ANSI/ASHRAE Addenda c, d, i, and p to
ANSI/ASHRAE Standard 62.1-2007

Ventilation for Acceptable Indoor Air Quality

Addendum c to 62.1-2007

Addendum d to 62.1-2007

TABLE 5-2 Airstreams

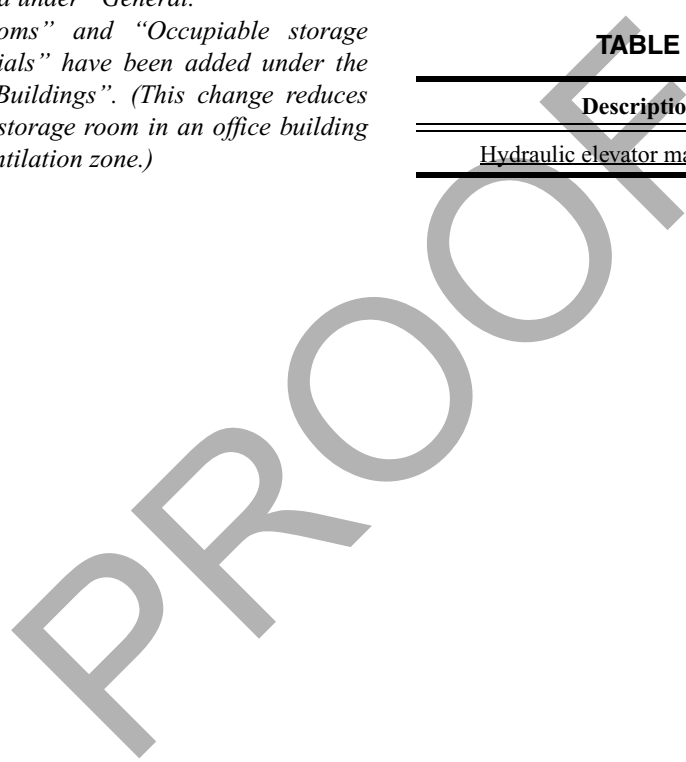
Add the following to Table 5-2:

Description	Air Class
<u>Hydraulic elevator machine room</u>	<u>2</u>
